# HISTORIC AND DESIGN REVIEW COMMISSION COMPLIANCE AND TECHNICAL ADVISORY BOARD

**HDRC CASE NO:** 2024-273  
**ADDRESS:** 221 W KINGS HWY  
**LEGAL DESCRIPTION:** NCB 3259 BLK 3 LOT E 50 FT OF 3 & W 60 FT OF 4  
**ZONING:** R-5, H  
**CITY COUNCIL DIST.:** 1  
**DISTRICT:** Monte Vista Historic District  
**APPLICANT:** Justin Howe/Guido Materials  
**OWNER:** STEVENS CHARLES S  
**TYPE OF WORK:** Fenestration modifications on rear accessory structure  
**APPLICATION RECEIVED:** July 12, 2024  
**60-DAY REVIEW:** September 10, 2024  
**CASE MANAGER:** Claudia Espinosa

## REQUEST:

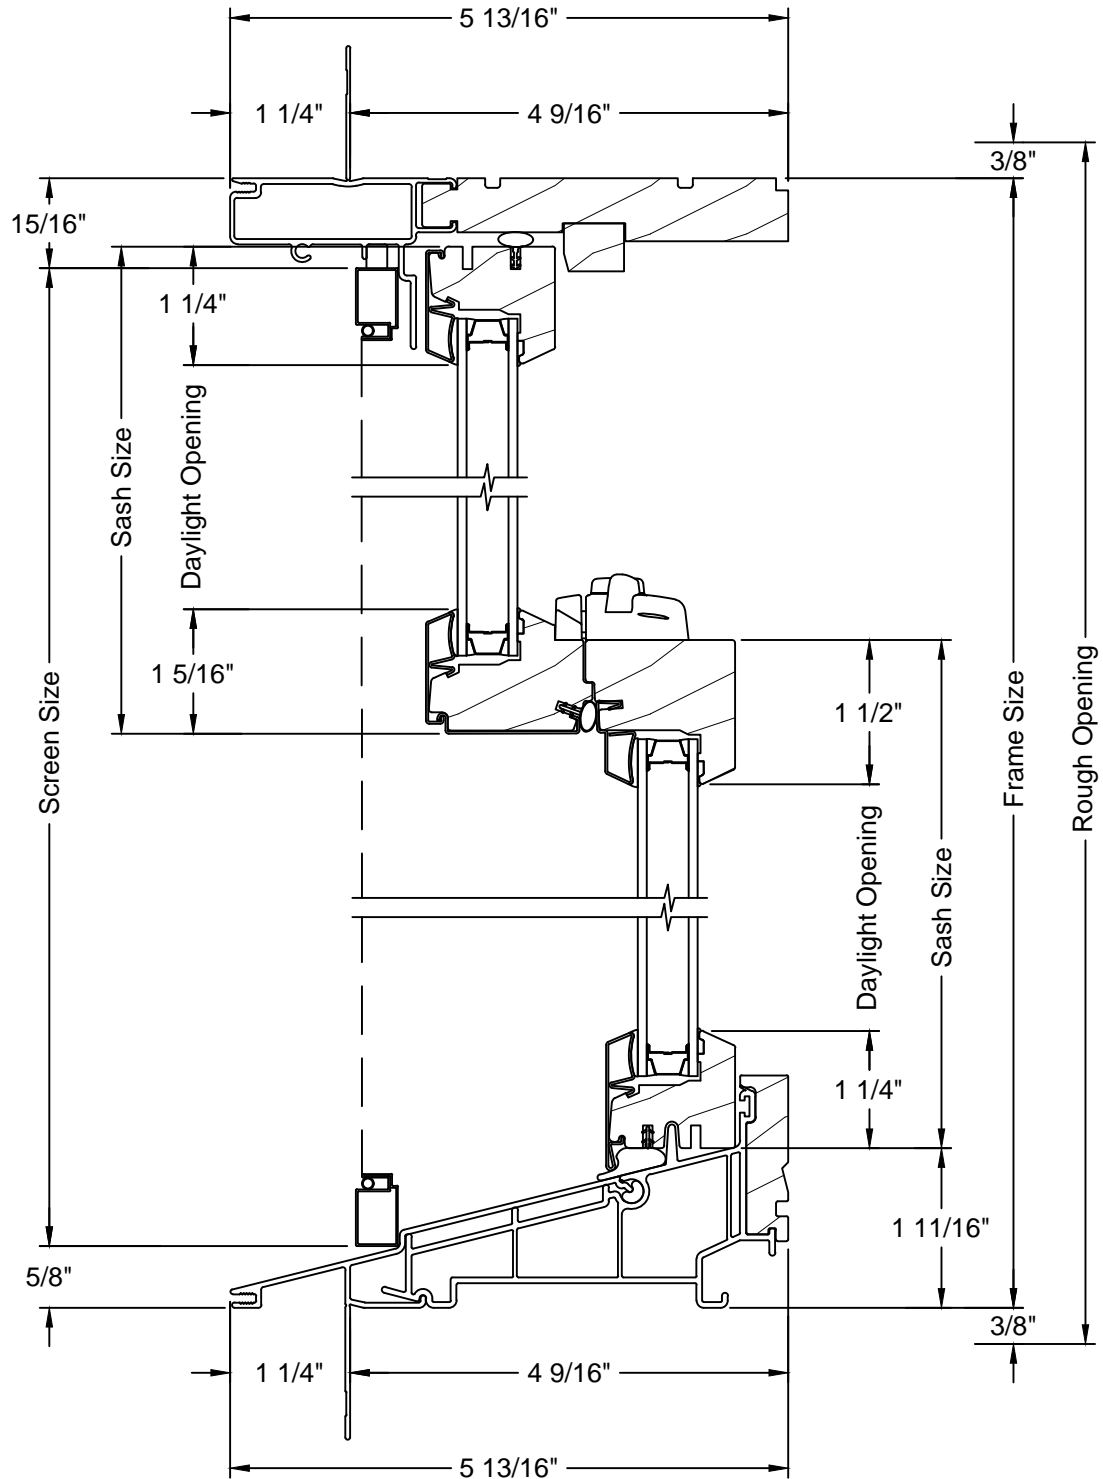
- b. FENESTRATION MODIFICATION (REAR ACCESSORY STRUCTURE) – The applicant has proposed to replace five (5) wood windows on the rear accessory structure with double hung clad wood windows. The Guidelines for Exterior Maintenance and Alterations 6.A.iv., states to install new windows to match the historic or existing windows in terms of size, type, configuration, material, form, appearance, and detail when original windows are deteriorated beyond repair. Additionally, Standards for Windows on Additions and New Construction state, new windows on additions should relate to the windows of the primary historic structure in terms of materiality and overall appearance. Windows used in new construction should be similar in appearance to those commonly found within the district in terms of size, profile, and configuration. While no material is expressly prohibited by the Historic Design Guidelines, a high-quality wood or aluminum-clad wood window product often meets the Guidelines with the stipulations listed below. Whole window systems should match the size of historic windows on property unless otherwise approved. Staff finds the proposed window is consistent with the Guidelines and Standards for Windows on Additions.

- c. DOOR REPLACEMENT – At this time, the applicant is requesting to replace the existing 6-divided lite and a 9-divided lite wood doors, that serve as entryways on either side of the existing garage doors with an 5-lite panel door. Per the Guidelines for Exterior Maintenance and Alterations 6.B.i, replace doors, hardware, fanlight, sidelights, pilasters, and entablatures in-kind when possible and when deteriorated beyond repair. When in-kind replacement is not feasible, ensure features match the size, material, and profile of the historic element. It is likely that the existing doors are not original to the structure, however the applicant has provided a similar product that conforms to the guidelines.

- d. GARAGE DOORS – The applicant has proposed to remove the existing garage doors, reduce the size of the opening, and install French doors. Per the 1931 Sanborn Map, the garage doors and awnings are not present and are not historically significant. The Guidelines for Exterior Maintenance and Alterations 9.B.i, Ensure that replacement garage doors are compatible with those found on historic garages in the district (e.g., wood paneled) as well as with the principal structure. When not visible from the public right-of-way, modern paneled garage doors may be acceptable. Staff finds that the removal of the non-historic garage doors, and the reduction of the opening to install French Doors is generally consistent with the guidelines.

Detached Garage at back left corner of property. 5 windows and 3 doors being replaced in detached garage.

Item 1, staff recommends approval of the replacement of wood windows, based on finding b with the following stipulations:

- i. That the applicant installs an aluminum clad-wood product that meet staff's standard window stipulations and submits updated specifications to staff for review and approval. The windows should feature an inset of two (2) inches within facades and should feature profiles that are found historically within the immediate vicinity. Meeting rails must be no taller than 1.25" and stiles no wider than 2.25". White manufacturer's color is not allowed, and color selection must be presented to staff. There should be a minimum of two inches in depth between the front face of the window trim and the front face of the top window sash. This must be accomplished by recessing the window sufficiently within the opening or with the installation of additional window trim to add thickness. Window trim must feature traditional dimensions and architecturally appropriate sill detail. Window track components must be painted to match the window trim or concealed by a wood window screen set within the opening.

- ii. Windows should be supplied in a block frame and exclude nailing fins. Window opening sizes should not be altered to accommodate stock sizes prior to approval.

Item 2, staff recommends approval of the replacement two wood doors with clad wood on the front façade (south-facing elevation) of the rear accessory structure, based on finding c.

Item 3, staff recommends approval of the removal of the garage doors, reduction of the opening, and installation a set of French doors, based on finding d.
